The Town of Hilton Head Island
Design Review Board Regular Meeting
Tuesday, July 16, 2019 – 1:15 p.m.
Benjamin M. Racusin Council Chambers
AGENDA

Bauer and Metro
 Landscape Plan for New Sign & Back of Building
 38 A New Orleans Road Hilton Head Island SC February 2019

SITE PLAN
NORTHRIDGE PLAZA IMPROVEMENTS
 TOWN OF HILTON HEAD ISLAND, SOUTH CAROLINA
 PREPARED FOR:
GATOR NORTHRIDGE PARTNERS, LLLP

HILTON HEAD SIGNS
30 Capital Dr. HHI 29926
(843)681-3513

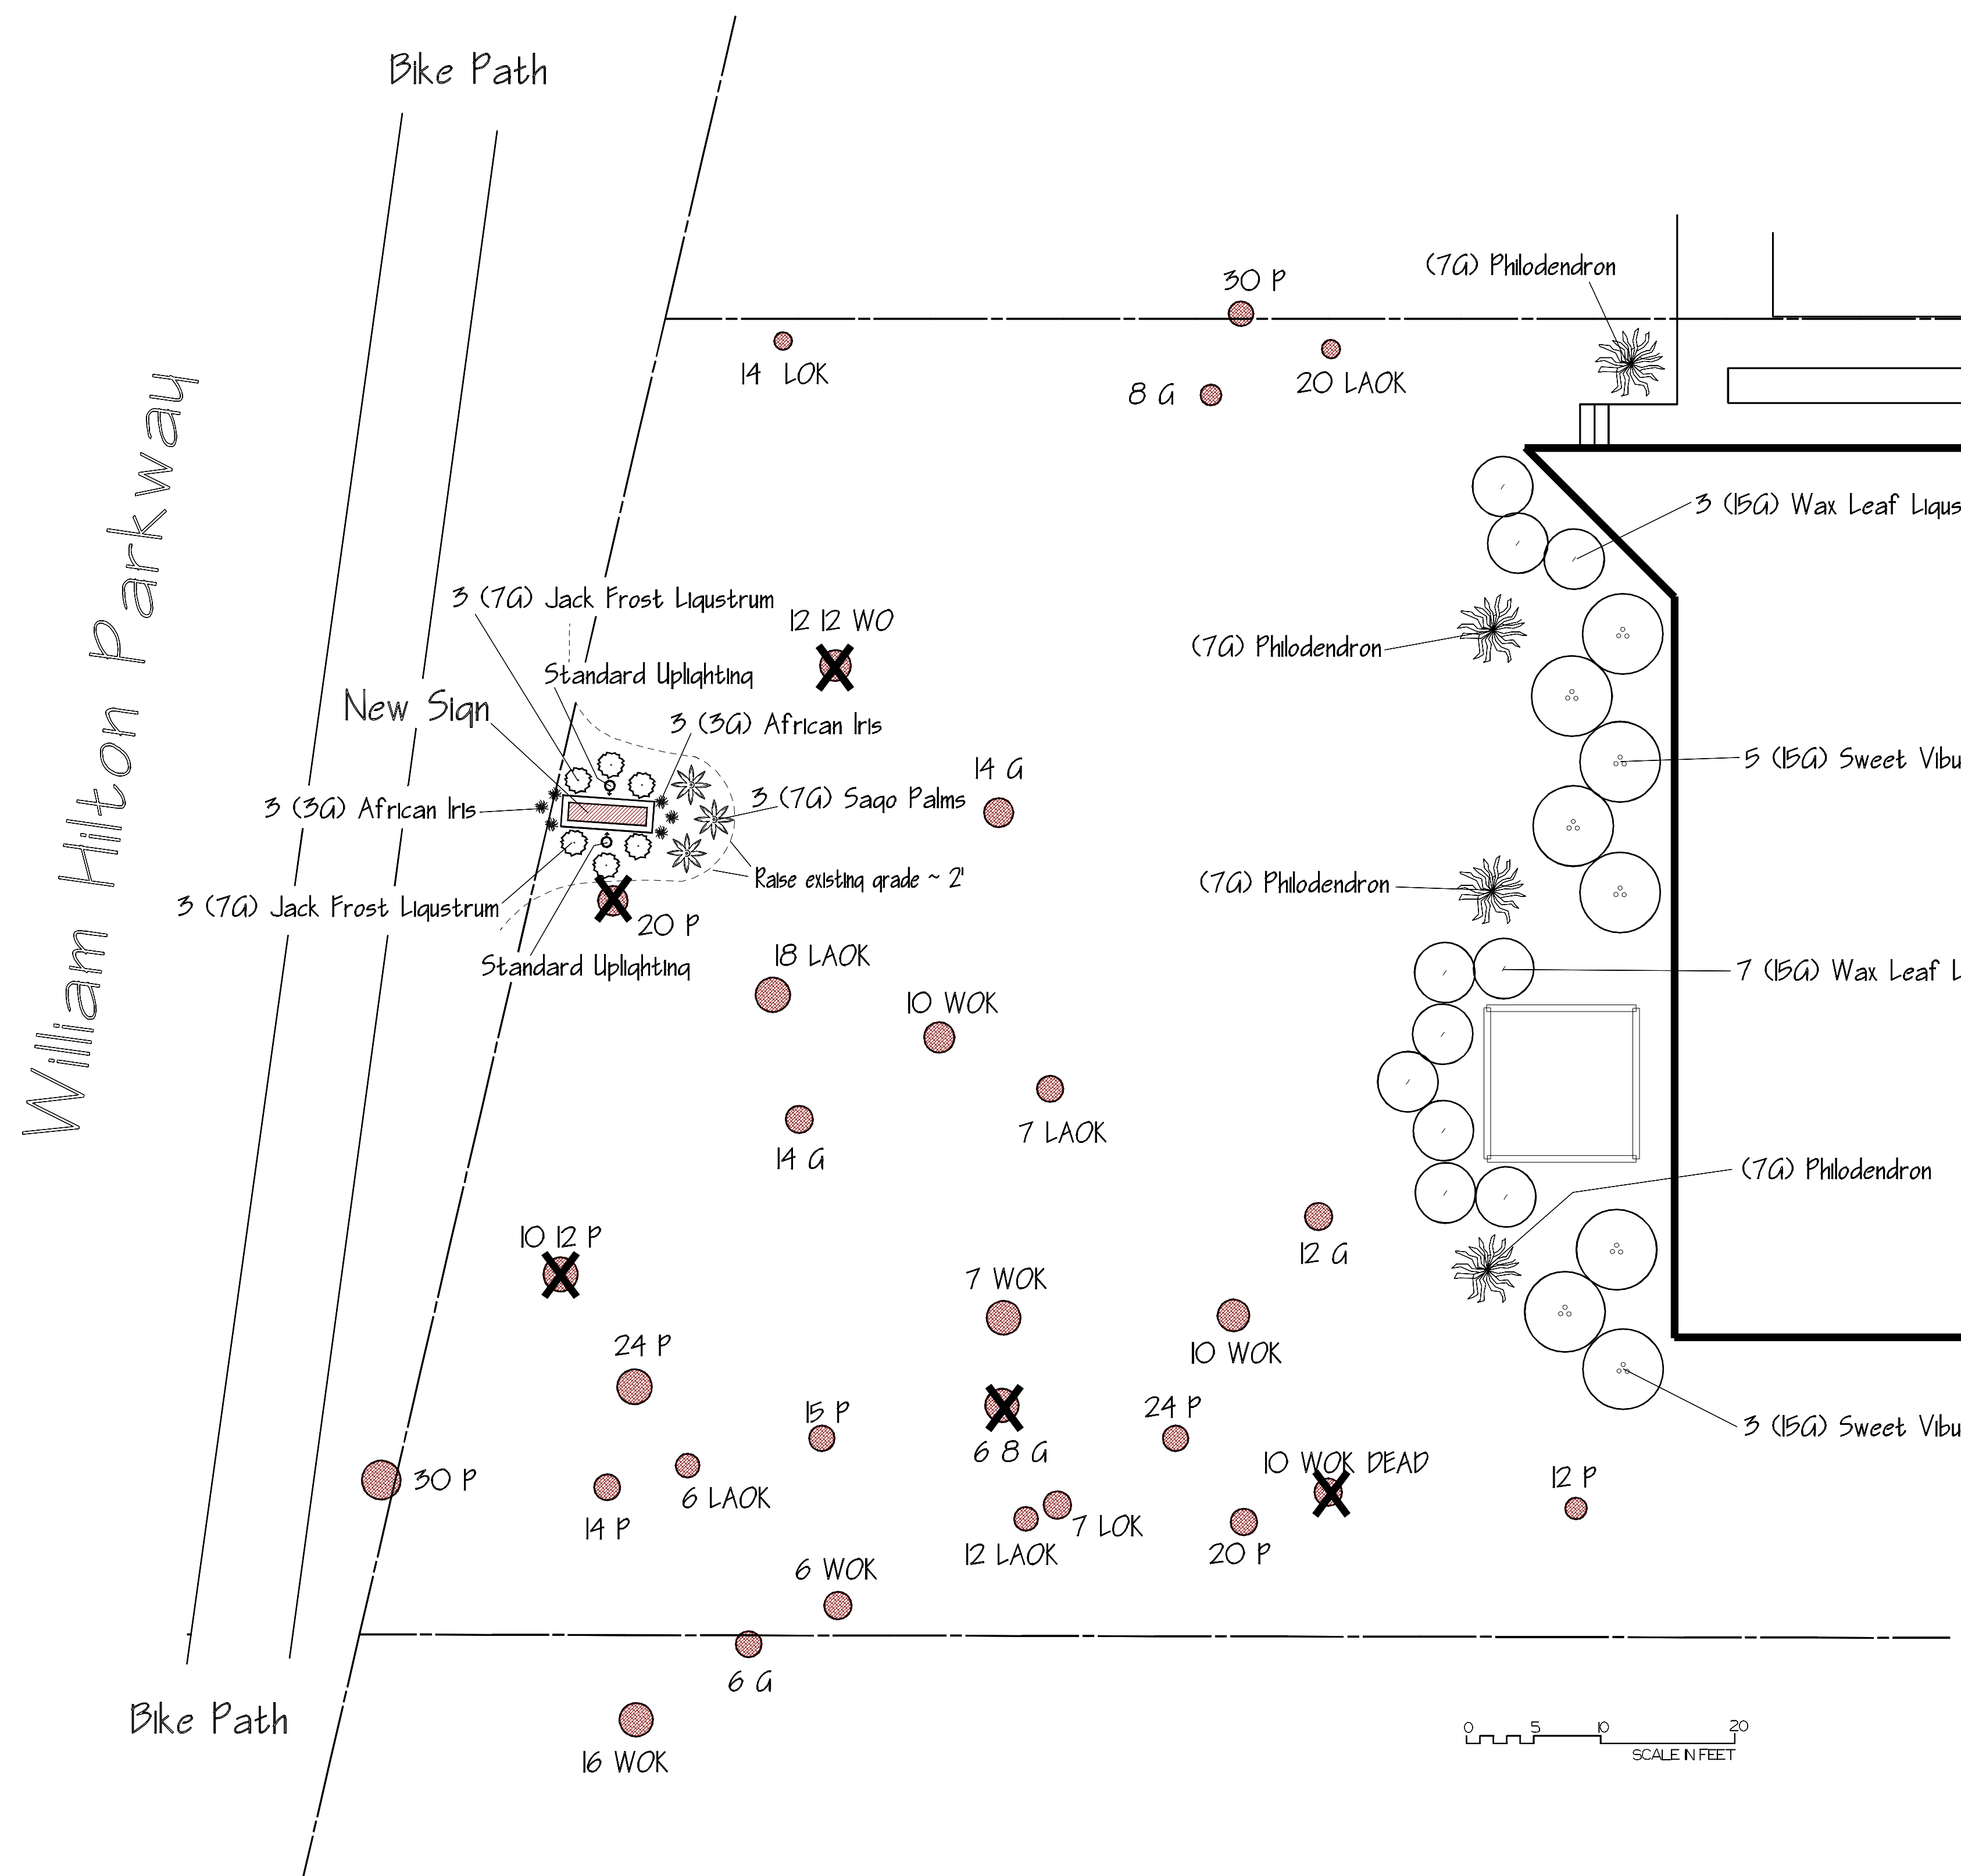
REQUIRED INFORMATION & DESIGN STANDARDS	Yes	No	N/A	Comments & Questions
The proposed landscaping matches or complements the existing vegetation on site.				<ol style="list-style-type: none"> 1. Ligustrums (Wax and Jack Frost) are exotic and invasive species and should not be used. 2. Philodendron are not native to the island, see Design Guide pages 18 thru 23 for guidance selecting plants and planting in buffers. 3. Indicate the trees that have been approved for removal in a previous Natural Resource Permit and those additional trees requested for removal on the planting plan. Show the buffer on the plans. 4. Eliminate the proposed 2’ berm.

NORTHRIDGE PLAZA
MONUMENT SIGN - #1
(EXISTING WITH PROPOSED NEW SIGN FACE)

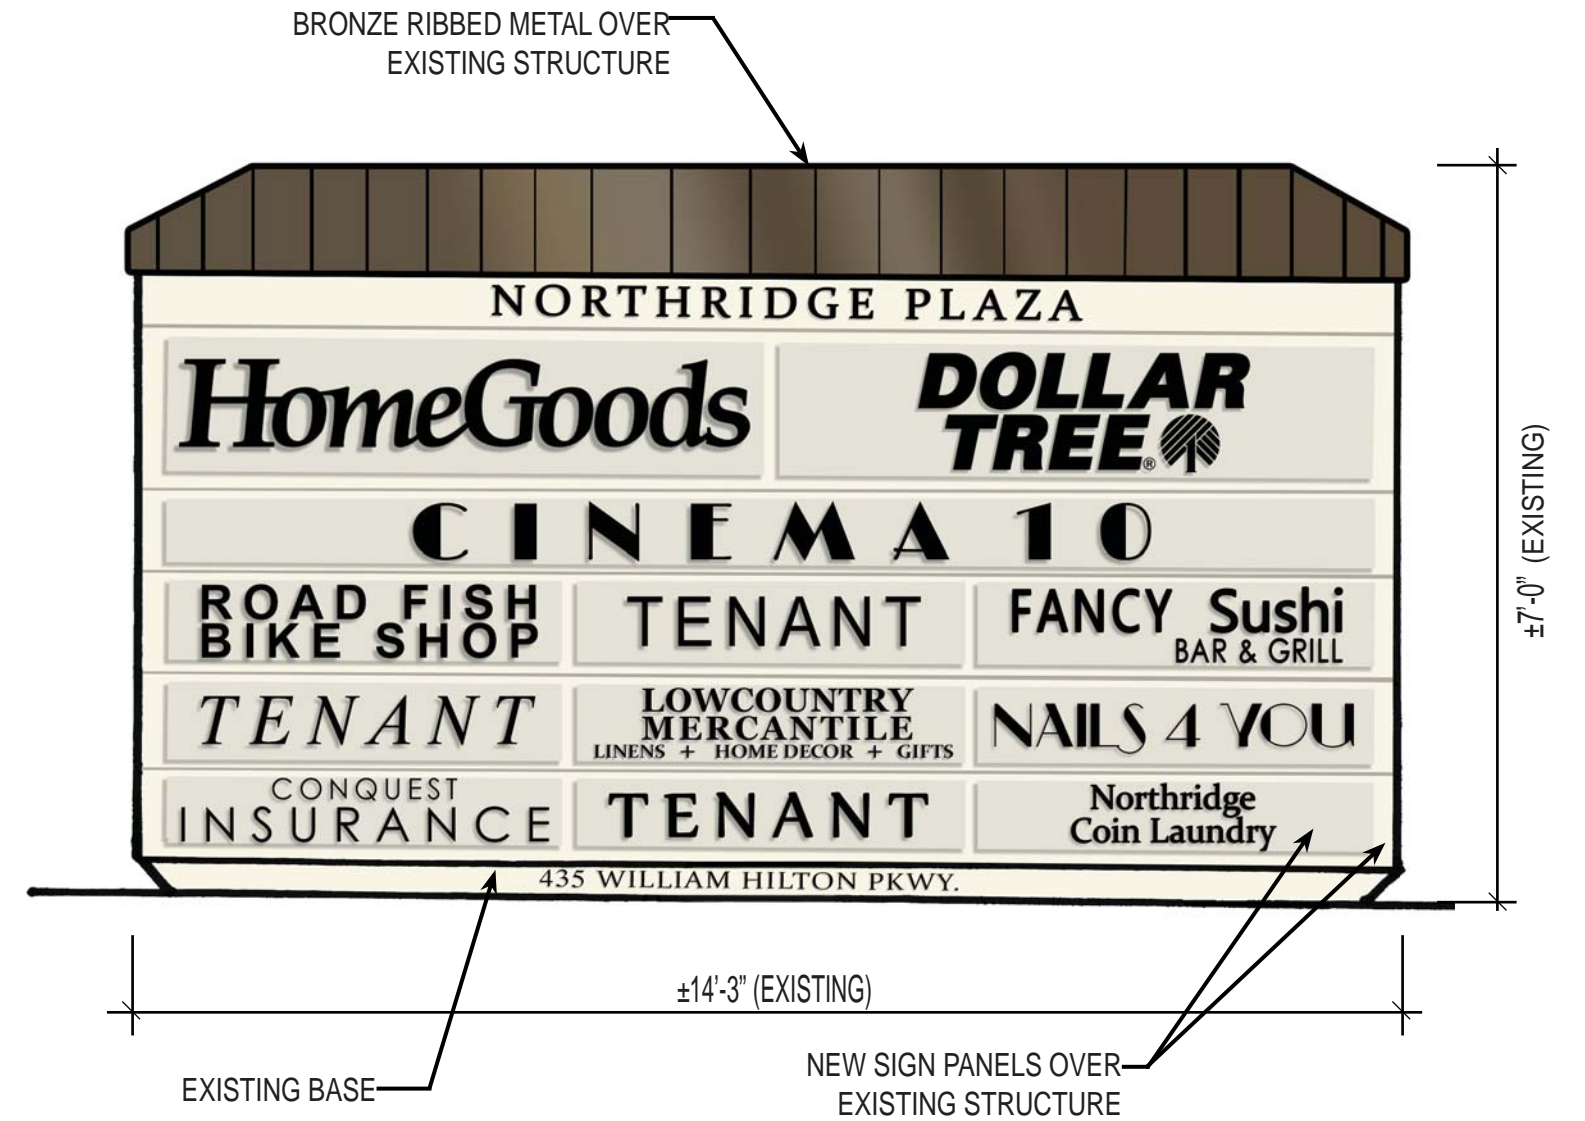
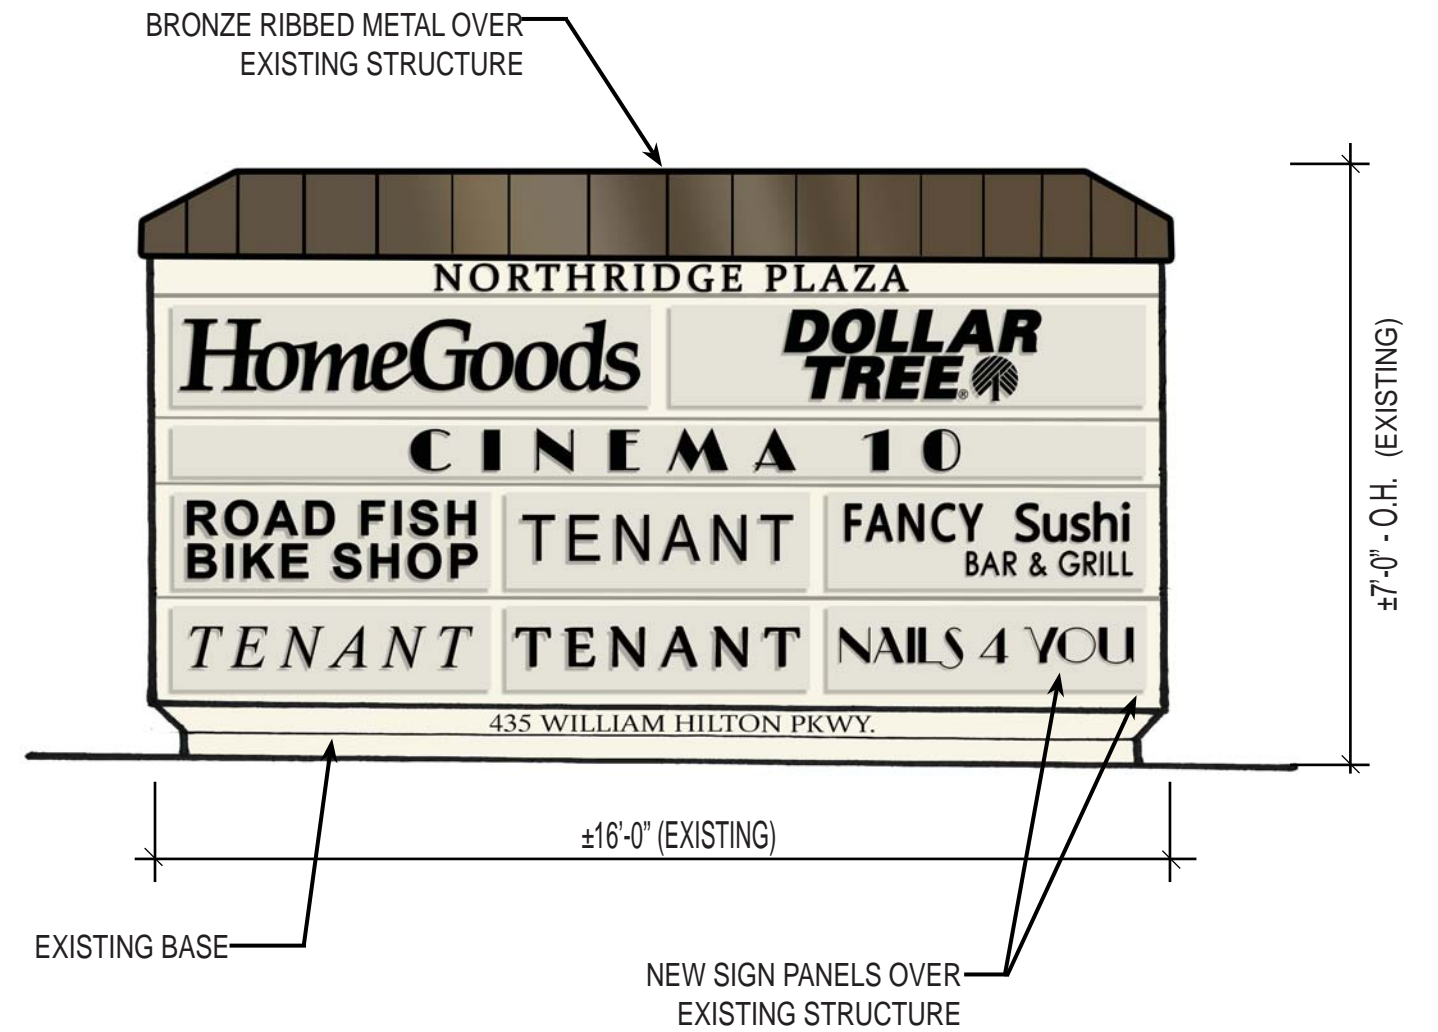
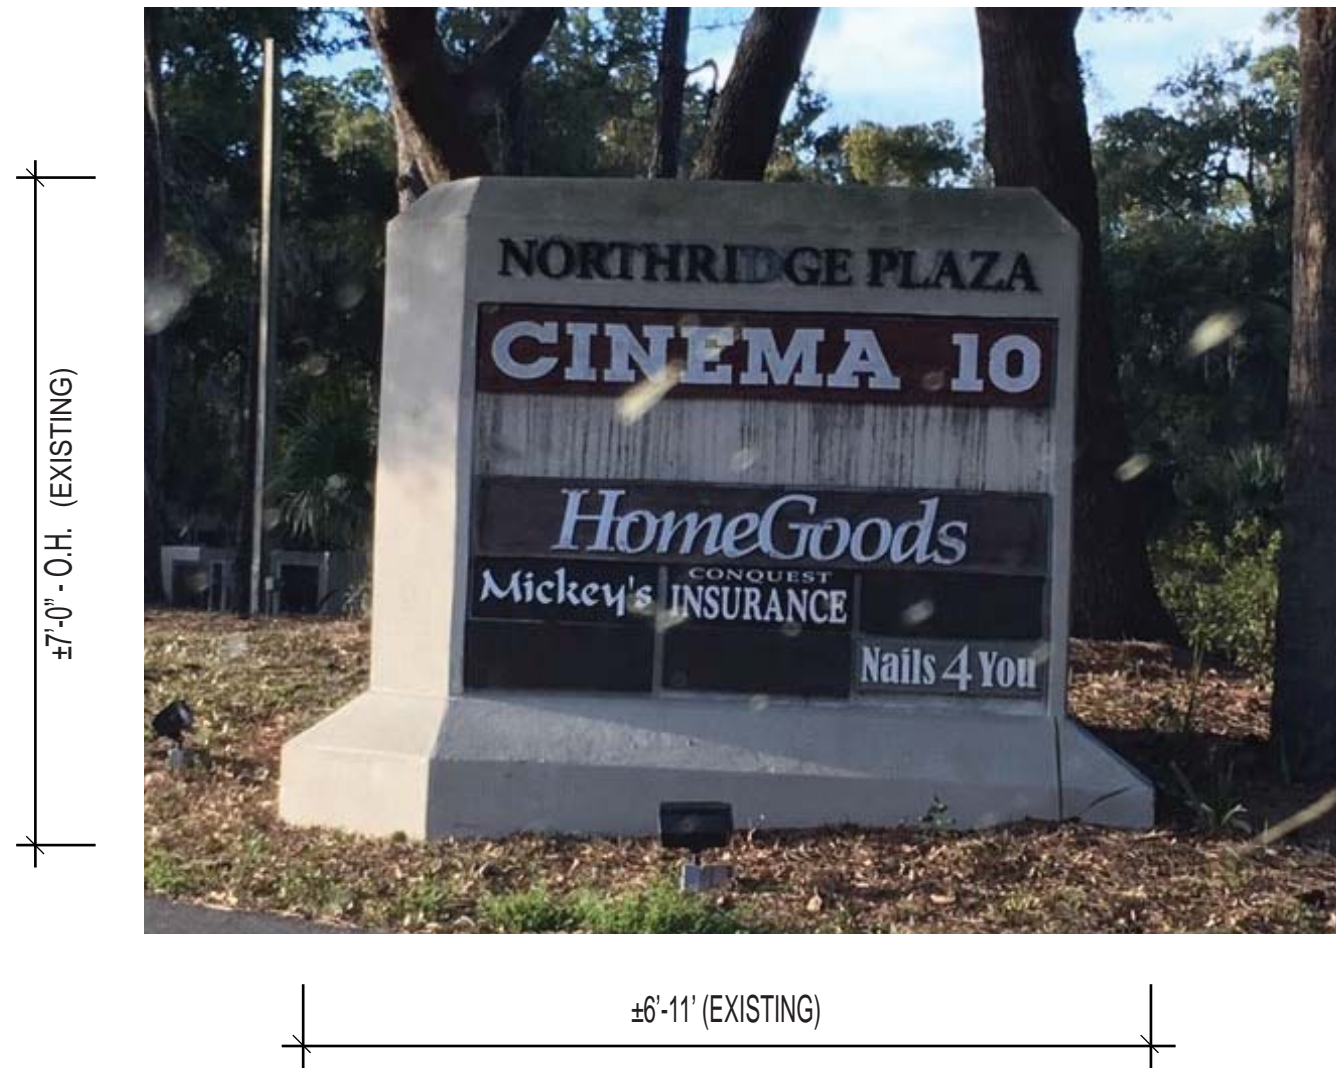
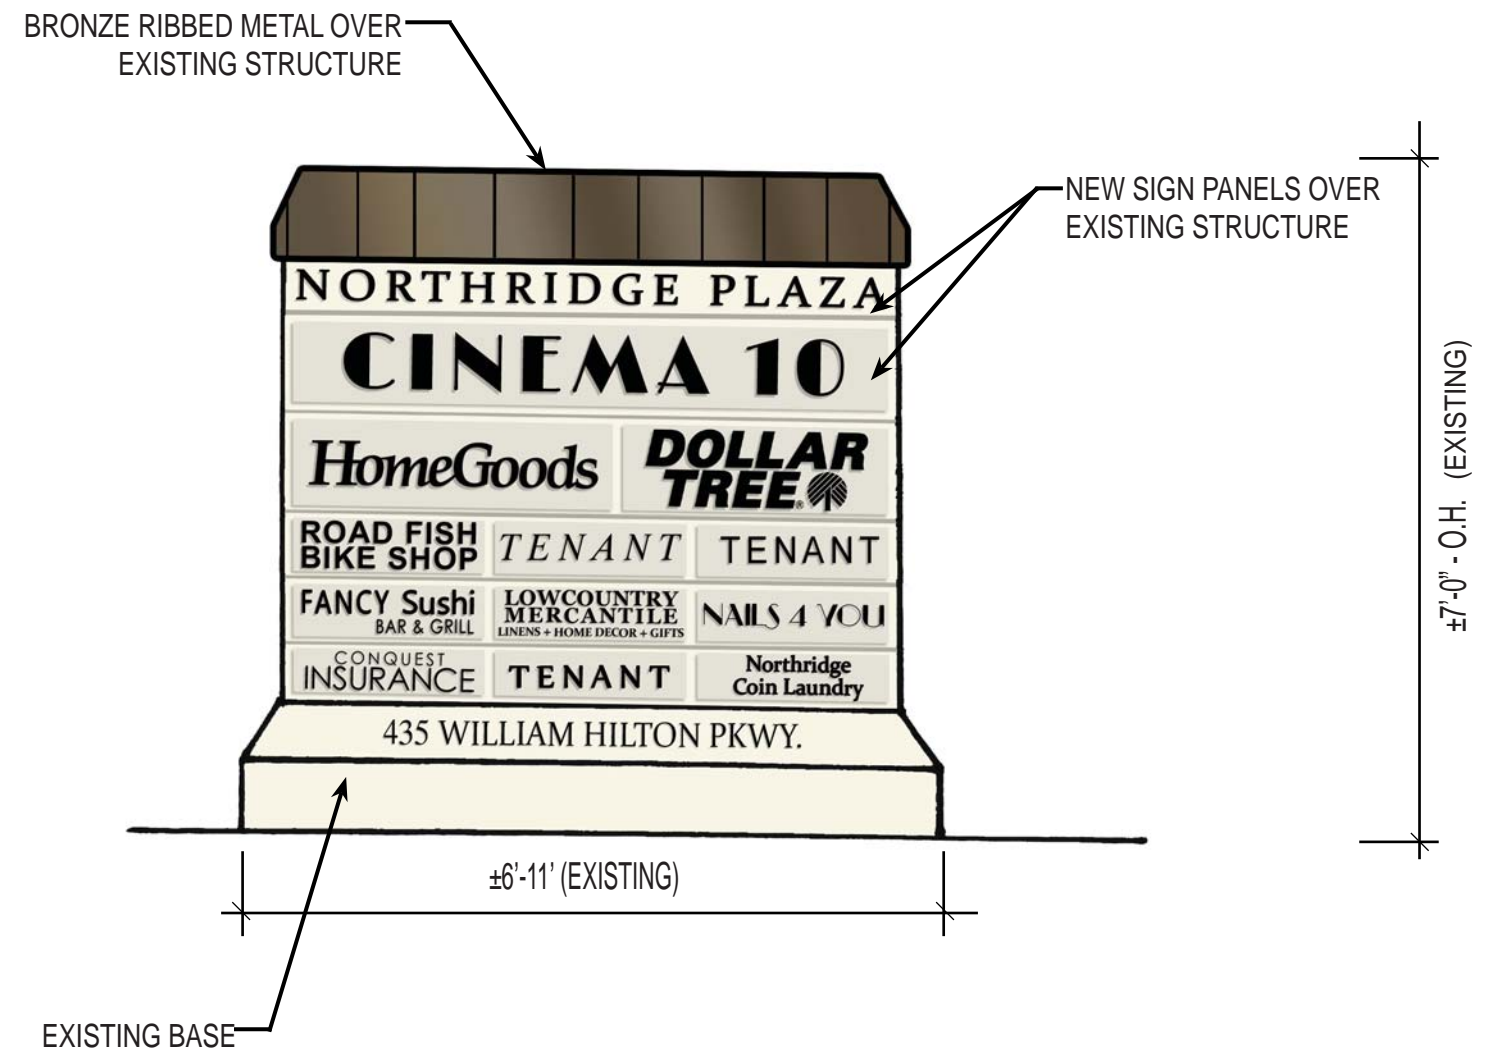
1. Create a sign system for approval and use by new tenants.
2. Town approved sign system should include tenant panel location and color.
3. More detail is required for approval.
4.
5.

REQUIRED MATERIALS	Yes	No	N/A	Comments & Questions
A color rendering or photo of the proposed sign with all required information. See requirements below. For multiple signs, number or letter each proposed sign, e.g. "Sign A", "Sign 3".		X		The color rendering should specify color name, number and manufacturer.
Photos of the location of the proposed sign with the sign superimposed <i>to scale</i> on the photos. <ul style="list-style-type: none"> • Provide photos close to the location, showing relevant details such as drive aisles, sidewalks, trees, etc. • Provide photos further away from the location, showing much of the surrounding area as possible. 		X		Provide photos depicting the existing signs and surrounding conditions.
An aerial photo, site plan, or sketch to scale showing property lines and the location of the sign. For multiple signs, indicate each sign location using the corresponding number or letter on the rendering, e.g. "Sign A". Note: Signs cannot be located off-premises.		X		Location and label on all three freestanding signs is unclear.

For new signs, a landscape plan. See requirements below.		X		Provide a detail of the landscaping around the Hwy 278 signs.

RENDERING – MATERIALS				
REQUIRED INFORMATION & DESIGN STANDARDS	Yes	No	N/A	Comments & Questions
Sign panel materials are listed, e.g. “2 inch thick HDU”.		X		Specify the finish surface of the renovated signs.
All additional materials and hardware is listed, e.g. “Black chains”.		X		Specify the tenant panel material and design. i.e. routed HDU or Cedar

RENDERING – DIMENSIONS				
REQUIRED INFORMATION & DESIGN STANDARDS	Yes	No	N/A	Comments & Questions
Dimensions of all structure or post features, e.g. caps, recesses, etc.		X		Please provide
Sign panel height & width.		X		Label tenant panel size.
Sign panel depth, e.g. “2 inch thick HDU”.		X		Please specify
How the sign is dimensional, e.g. “Text and border are raised” or “Text and border are recessed”.		X		Please provide
Depth of dimension. Note: The minimum required depth is 0.25 inch. Larger signs may require more depth.		X		Not provided
Letter heights		X		Not provided.
Logo dimensions, if applicable.		X		Not provided.

RENDERING – DESIGN				
REQUIRED INFORMATION & DESIGN STANDARDS	Yes	No	N/A	Comments & Questions
The street address of the site is shown in 4 inch tall numbers on both sides of the sign. Note: The street name may be also required if the site accesses more than one street.		X		No dimension provided. Address must be at the top of the sign so it is not obscured by vegetation.
The number of fonts does not make the sign look busy.		X		Limit the number of fonts.
Sign panels: A description or photo of the background texture of the sign, e.g. “Wood grain”, “Pebble finish”, “Stucco finish”, etc.		X		Not provided.
Channel letters: Letter depth, e.g. “3 inch thick aluminum”		X		Not specified.
Letter heights		X		Not specified.
Channel letter signs: Backer height, width & depth, if applicable.		X		Not specified.
Channel letter signs: Standoff from the building or backer, e.g. “1 inch standoff”.		X		Not specified.

RENDERING – COLORS				
REQUIRED INFORMATION & DESIGN STANDARDS	Yes	No	N/A	Comments & Questions
Every color used is identified by manufacturer name and number, e.g. “SW 6112 Biscuit”, “BM OC-95 Navajo White”. Pantone colors are not used.		X		
Colors match the other signs on site for that business or development.		X		Create a sign system for approval
Background colors are earth tones: green, brown, beige, and grey.		X		Not specified.
Channel letters: specify that the return color matches the letter face color.		X		Specify on the plans.

LIGHTING				
REQUIRED INFORMATION & DESIGN STANDARDS	Yes	No	N/A	Comments & Questions
New lighting: Rendering or cut sheet specifies the light will be white.		X		Specify on the drawings.
Channel letters: Rendering or cut sheet states light will shine around letters, i.e. “Halo”.		X		Specify on the drawings.
Channel letters: Rendering states UL or any other required labels will be placed on the top of the letters.		X		Specify on the drawings.
